#### PLANNING AND ZONING COMMISSION ACTION ITEM STAFF SUMMARY JUNE 1, 2022 PLANNING AND ZONING COMMISSION MEETING

#### Consideration of Resolution No. PZ 02-22, Series of 2022. (PUBLIC HEARING) A RESOLUTION APPROVING A LEVEL III DEVELOPMENT PERMIT FOR A NEW DECK ON A COMMERCIAL BUILDING LOCATED AT 765 W. ANEMONE TRAIL.

TO:ROB FORSLUND, CHORD DESIGN STUDIOSFROM:NED WEST, SR. TOWN PLANNERSUBJECT:COMMERCIAL DECK – SNARF'S SANDWICHES – 765 W. ANEMONE TRAILDATE:MAY 11, 2022

The Town of Dillon Development Review Committee has reviewed the commercial deck application for the Snarf's Sandwiches and has determined that the plans submitted on May 3<sup>rd</sup>, 2022 are acceptable to move forward to the Planning and Zoning Commission for their review in a public hearing.

#### SITE PLAN

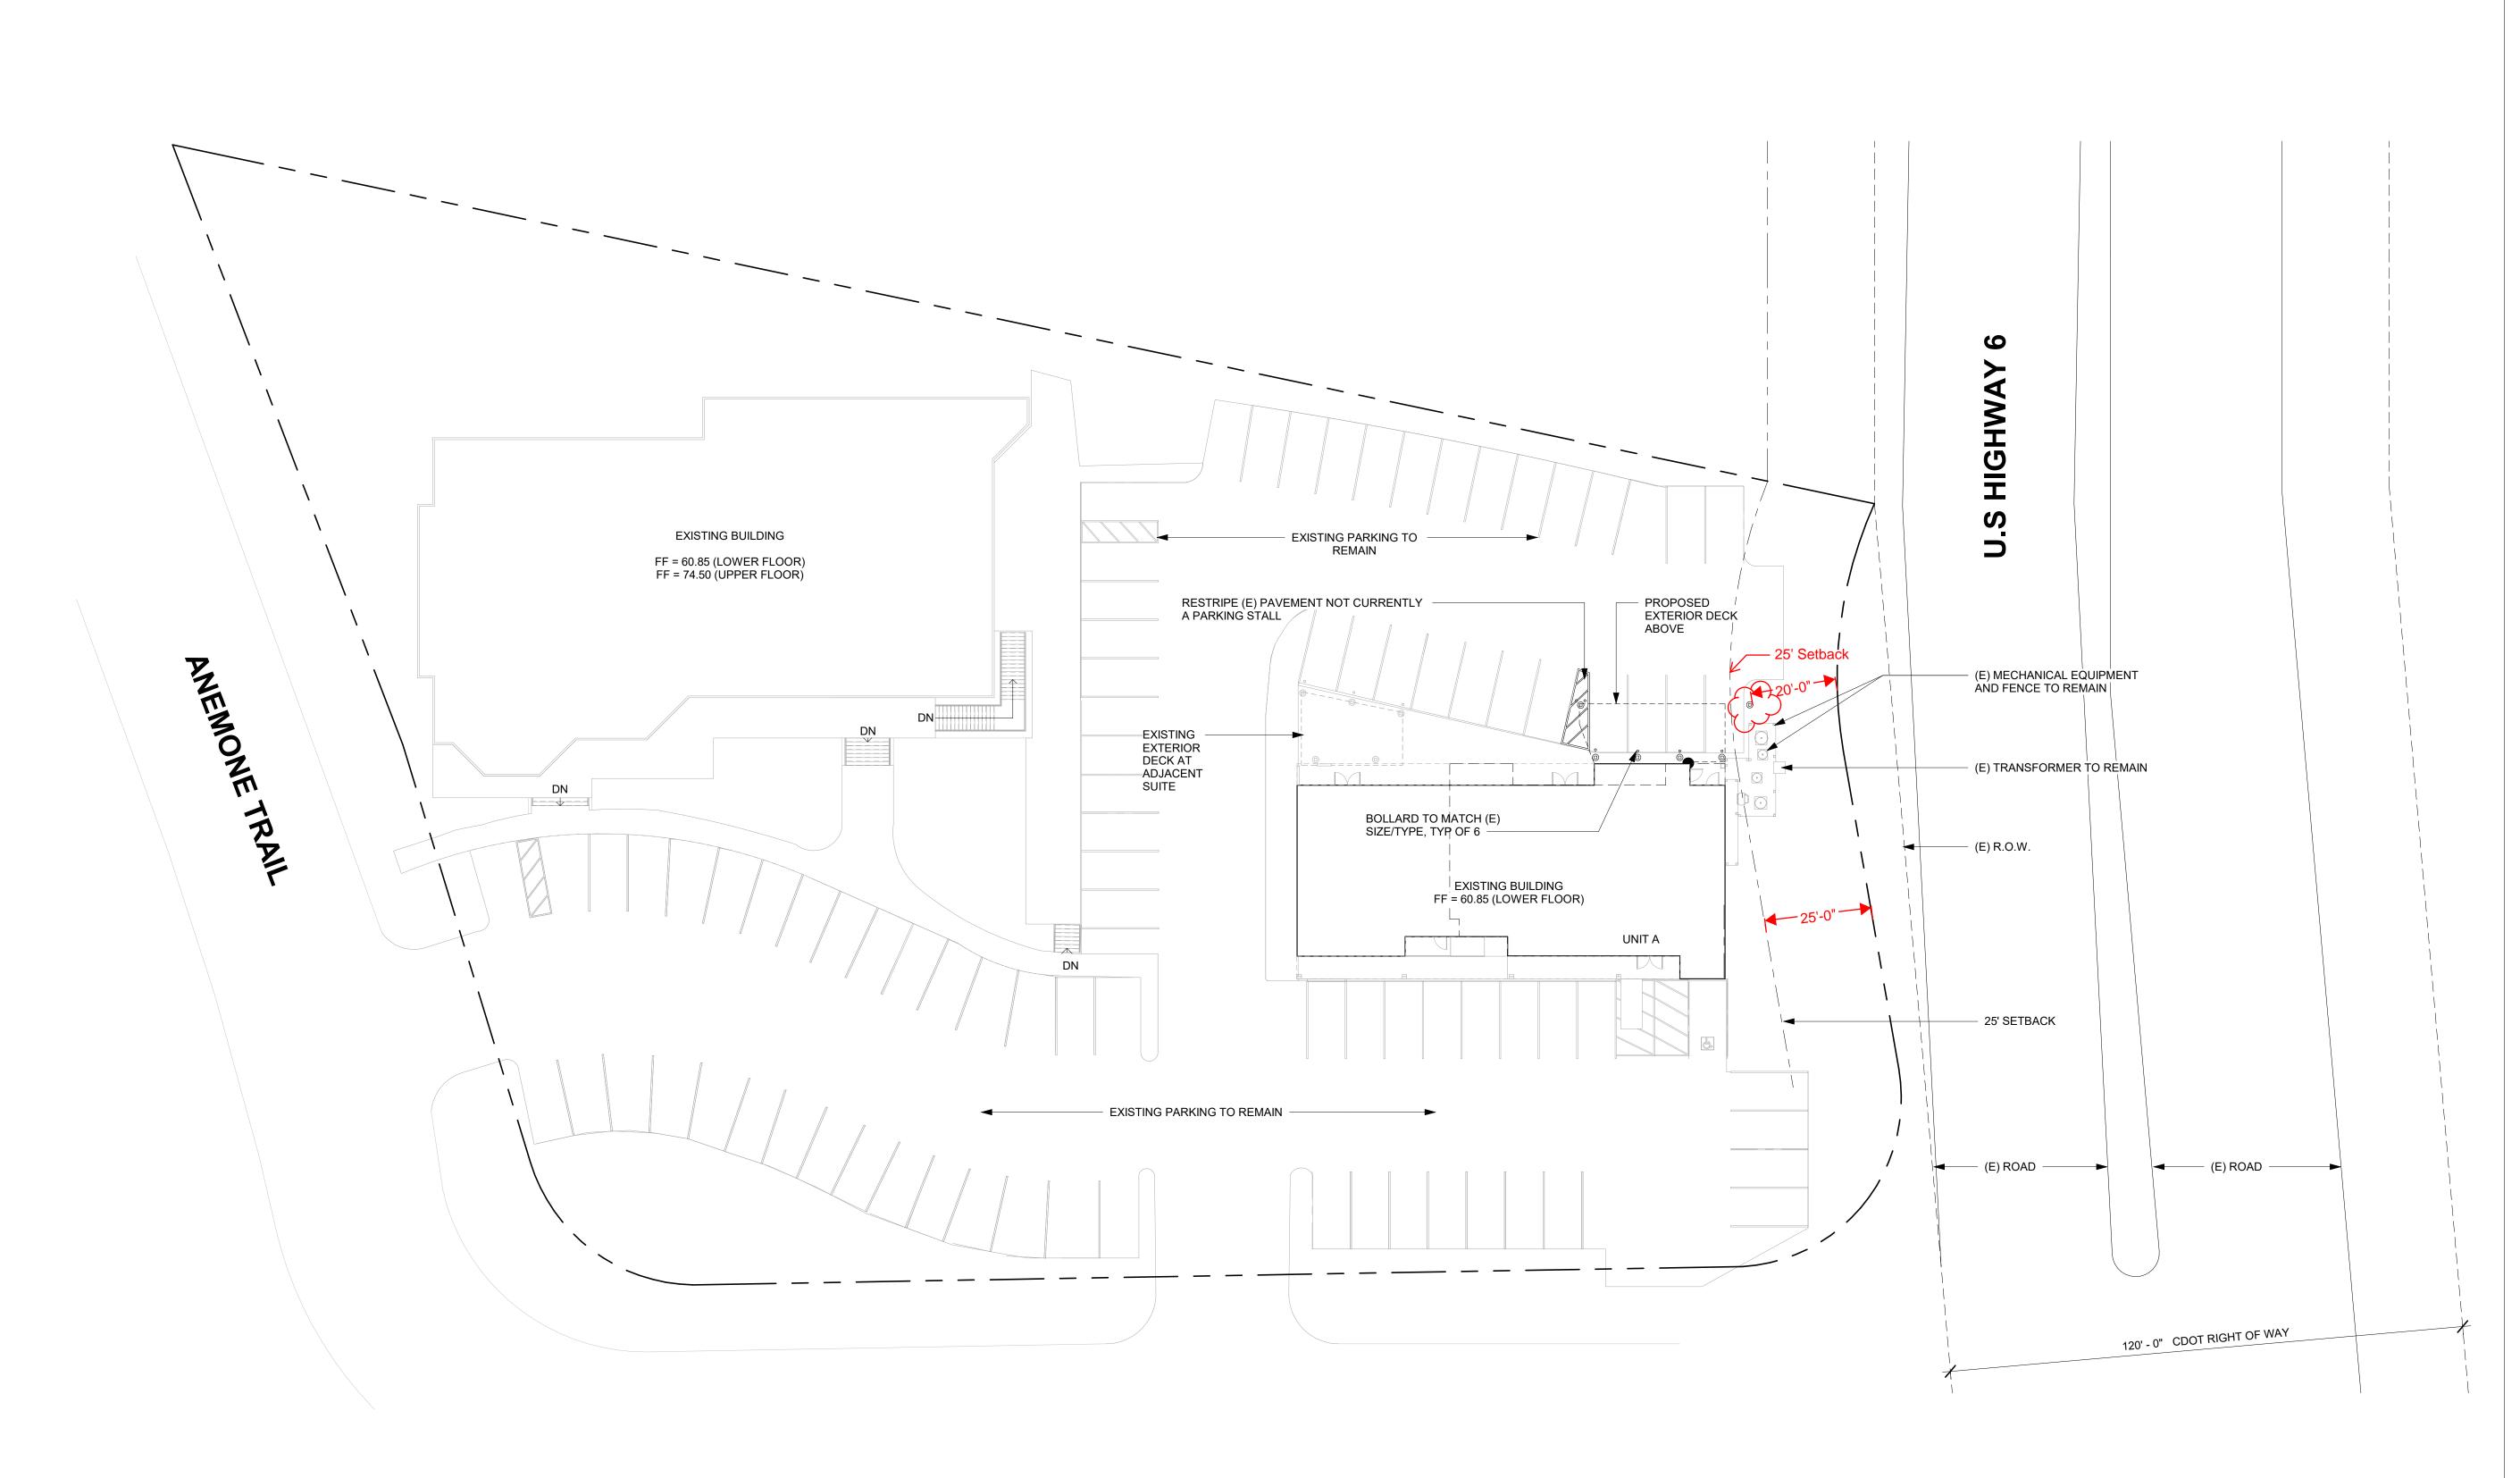
- 1. The Proposed deck support caisson / foundation is located twenty (20) feet from the northern property line as shown on page A100 of the plans dated May 3, 2022.
